## ANN ARBOR HISTORIC DISTRICT COMMISSION

### Staff Report

**ADDRESS:** 403 W Liberty Street, Application Number HDC19-080

**APPLICATION:** The applicant seeks HDC approval to modify a dormer/bump on the roof above the attic stairwell.

## WEST ELEVATION

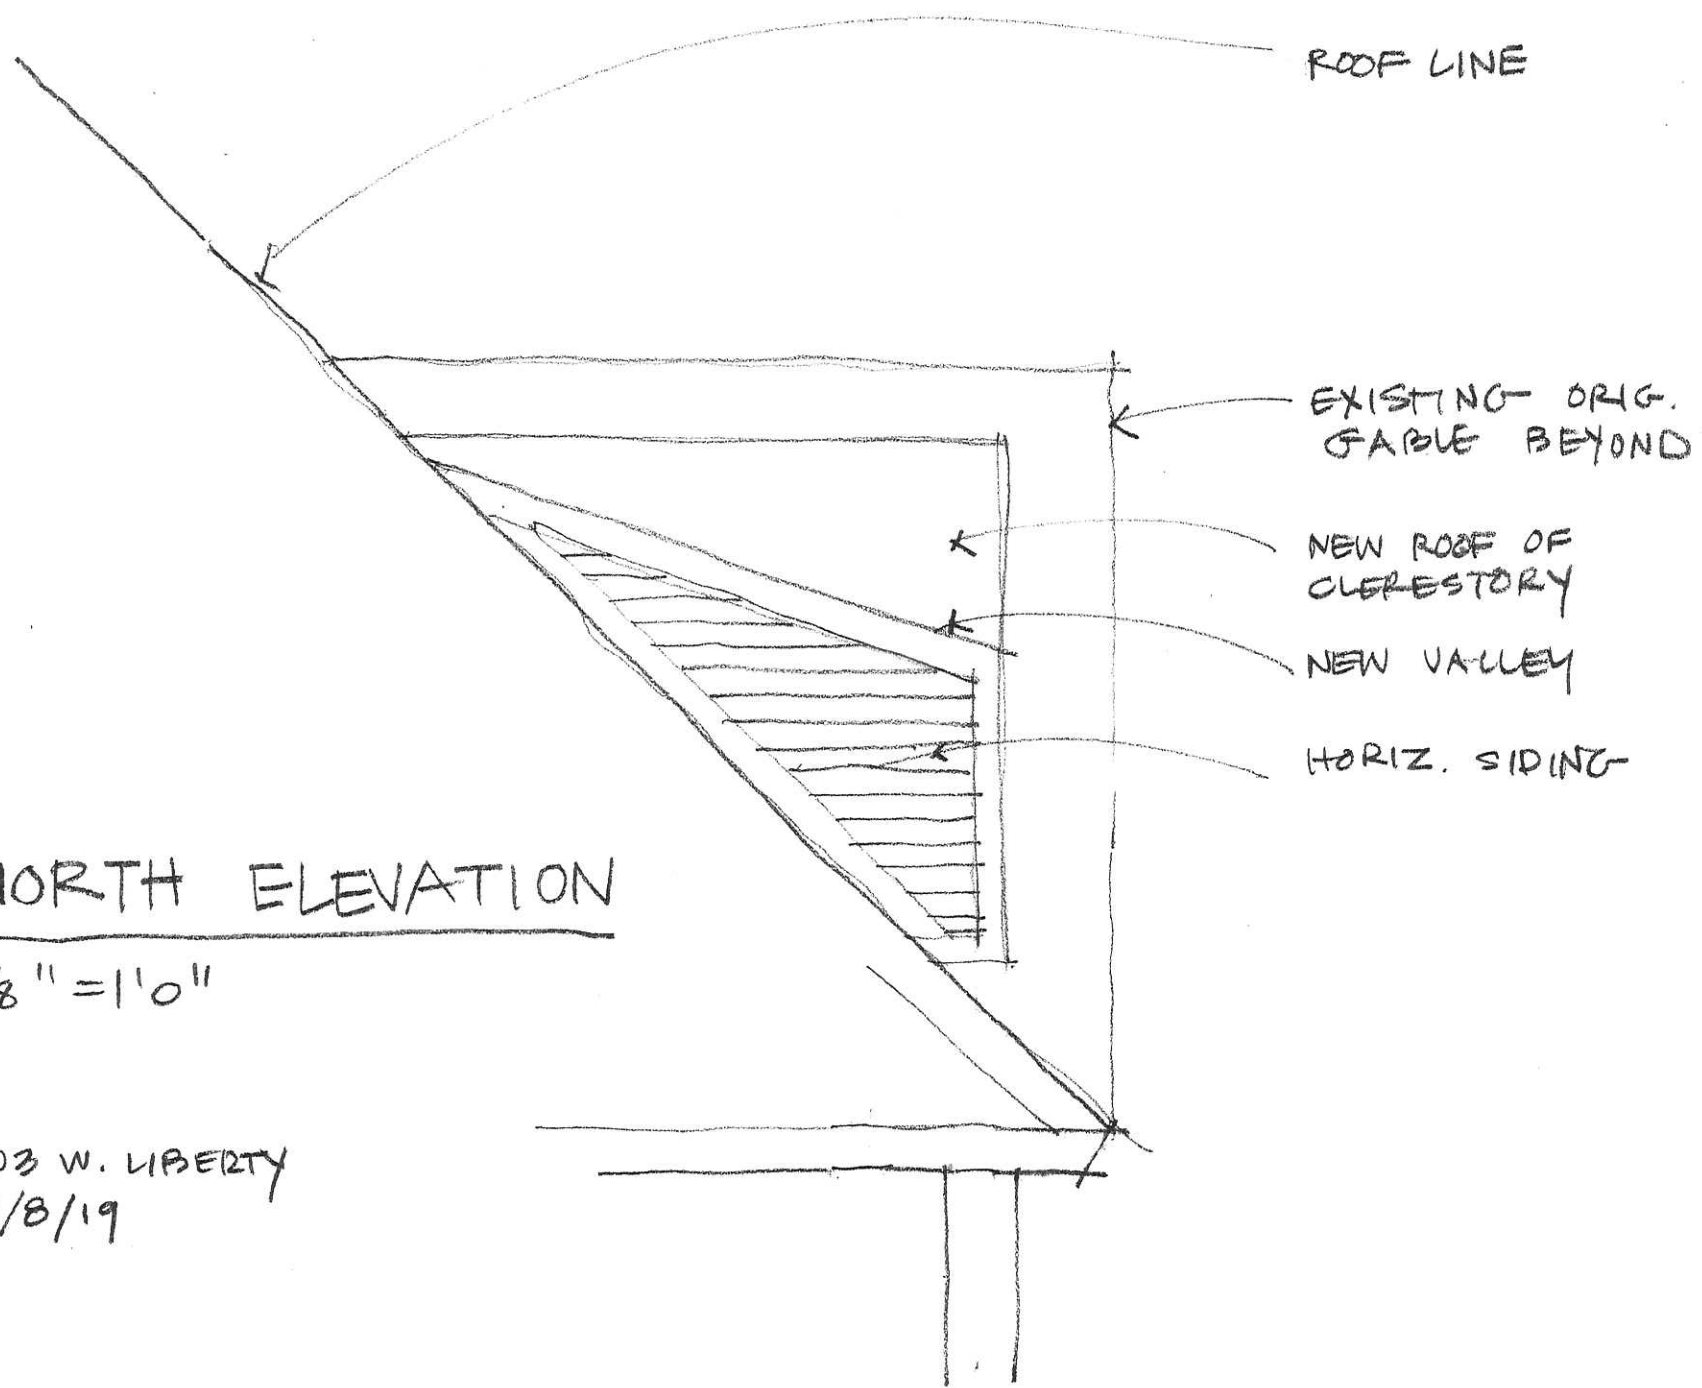
1. The house is currently being converted to a duplex, with a two bedroom apartment in the walk-out basement and a four-bedroom apartment on the upper three floors. A lower profile version of this stair headroom bump with a skylight was approved in the 2018 HDC package, but it is reportedly not buildable as approved. The bump has a flat roof which is leaking water (black mold can be observed on the stairwell ceiling). The owner desires to change the roof pitch on the bump to allow water and snow to shed, and proposes an extension to the gable. The new gable on top of the bump would contain a picture

window and extend the existing gable 3'. The new gable ridge would be 18" below the main roof ridge.

3. The proposed work is very conspicuous, and exacerbates the bump rather than minimizes it. It is especially problematic given its prominent location on the side of the house. Staff has requested an additional drawing of the north elevation to further clarify what it will look like.

4. Relating this to the Secretary of the Interior's Guidelines: This is a more than minimal change to the west side gable, a character-defining feature of the house. It alters the appearance and spatial relationships of the roof, and the massing, size, and scale of the gable extension is visually incompatible and does not protect the historic integrity of the property. It could be removed in the future without impairing the historic structure.
